ARLINGTON, VA

FBC ADVISORY WORKING GROUP MEETING
FOR YW CAPITAL DEVELOPMENT

02/11
2020

**PROPOSED MODIFICATION #2 (PREVIOUSLY APPROVED):
SITING SPECIFICATIONS (SETBACK FROM RBL)**

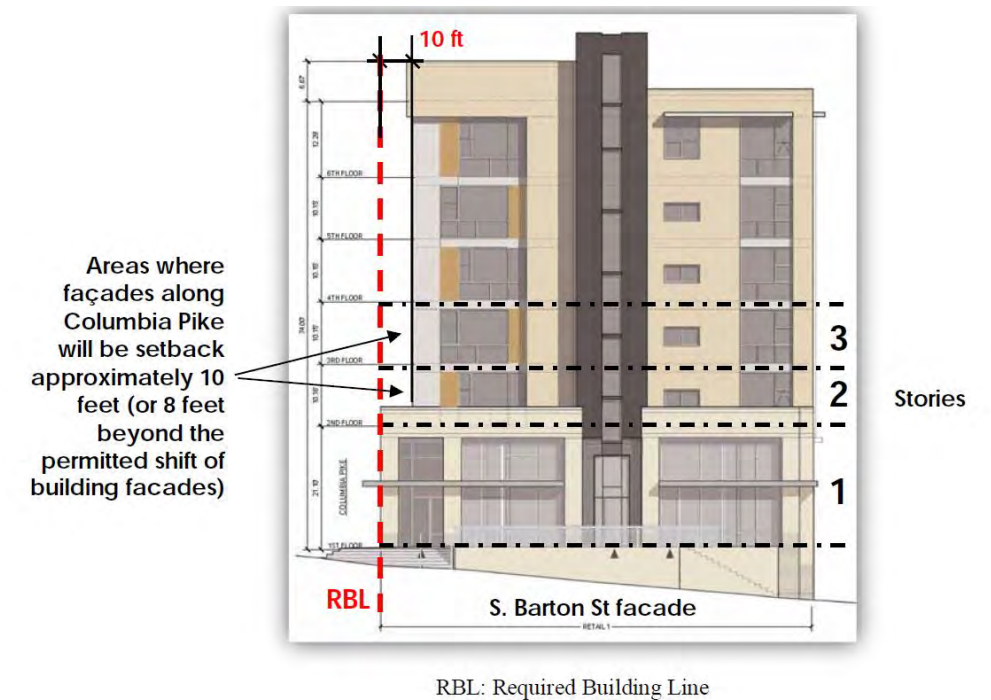
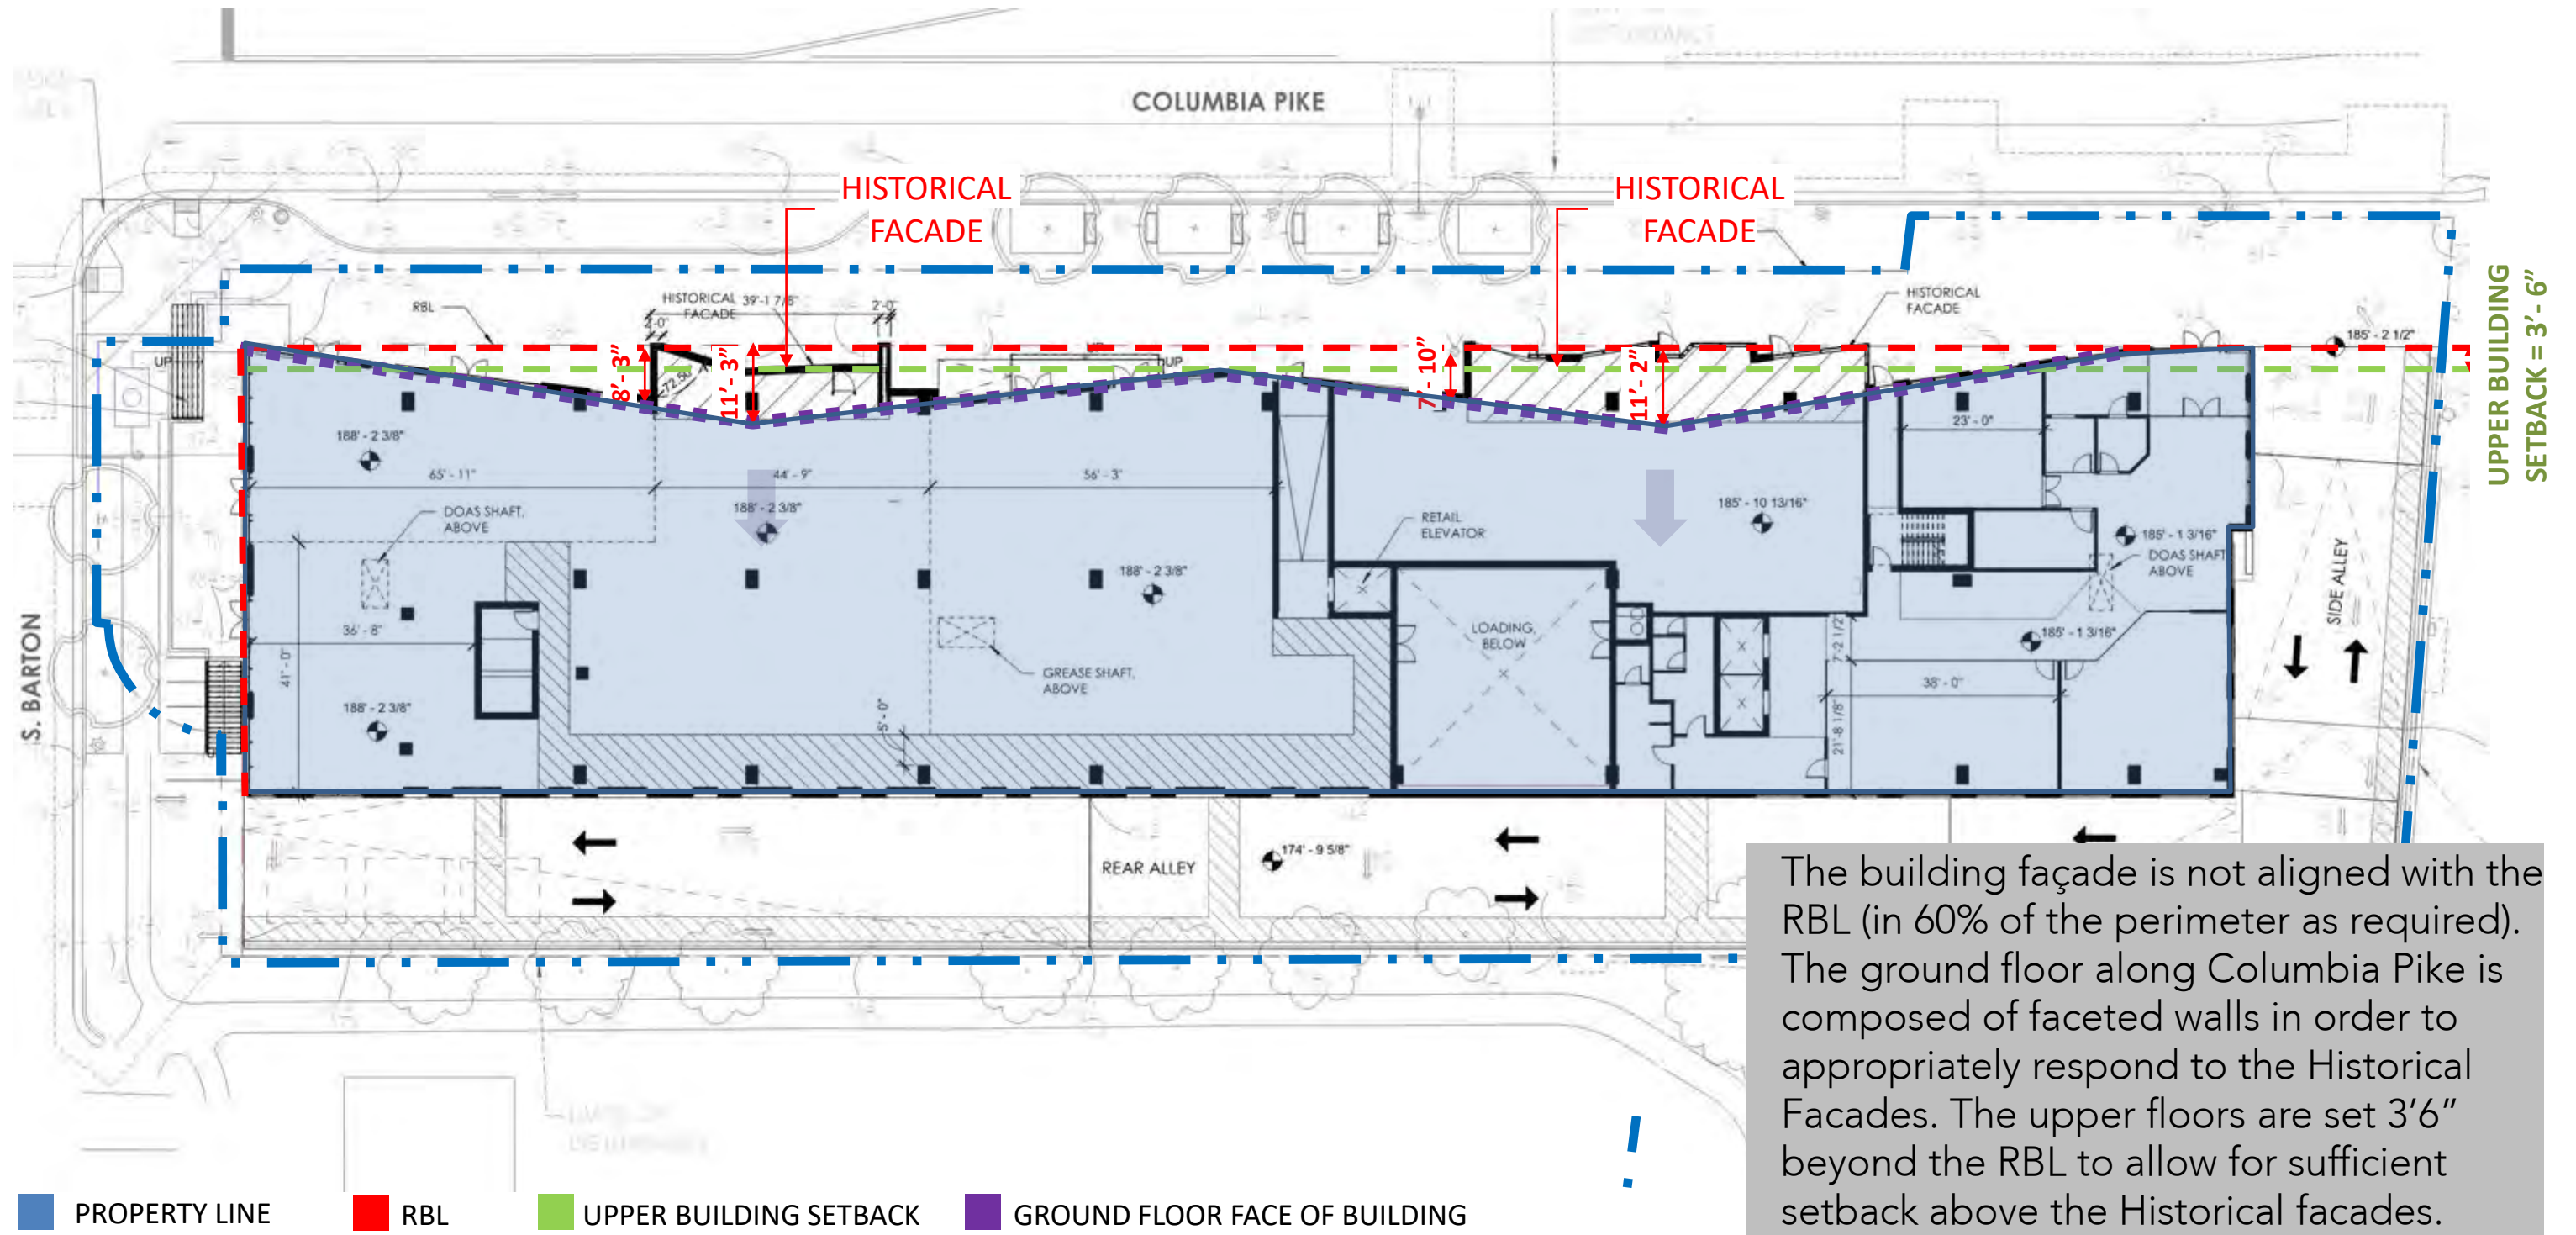
Proposed Modification #2: Siting Specifications. The Required Building Lines (RBLs) are shown on the Regulating Plan, framing the building edges along Columbia Pike and S. Barton Street. As prescribed in the Main Street BES for this site, the building's first three stories are required to be located along the two RBLs for a minimum of 75% of the frontage. While the ground-story retail level meets this criteria, the second and third residential levels are intentionally setback to distinguish the existing facades from the new structure above (See Exhibits 10a and b). This is the result of extensive work by the applicant with the HALRB to successfully emphasize the base of the building and distinguish the historic facades from the upper stories of the new building while maintaining a unified design for the overall project.

While the FBC permits building jogs of up to two feet away from the RBL, the proposed design includes a continuous building shift of approximately ten feet beyond the RBL. However, in preserving the historic facades, staff agrees with the above approach and supports the proposed modification. In this instance, staff believes that distinguishing the historic facades from the upper stories is appropriate and that creating only one floor that frames Columbia Pike instead of three, will not create a significant impact along the streetscape experience.

PROPOSED MODIFICATION #4:
WINDOW CONFIGURATION

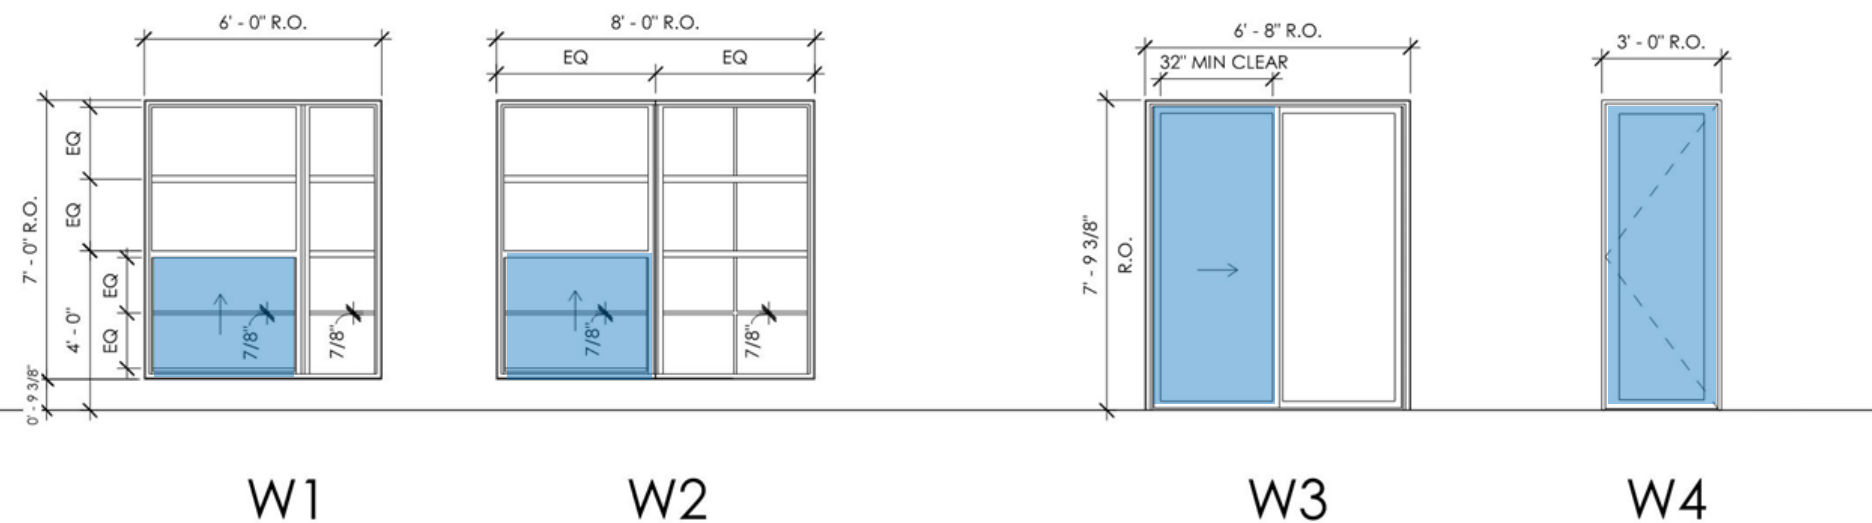
Horizontal emphasis is one of the identifying features of Art Moderne. The building design strives to complement and relate to the Historical facades, and therefore not all the specific window configuration requirements can be met.

33% operable proposed:
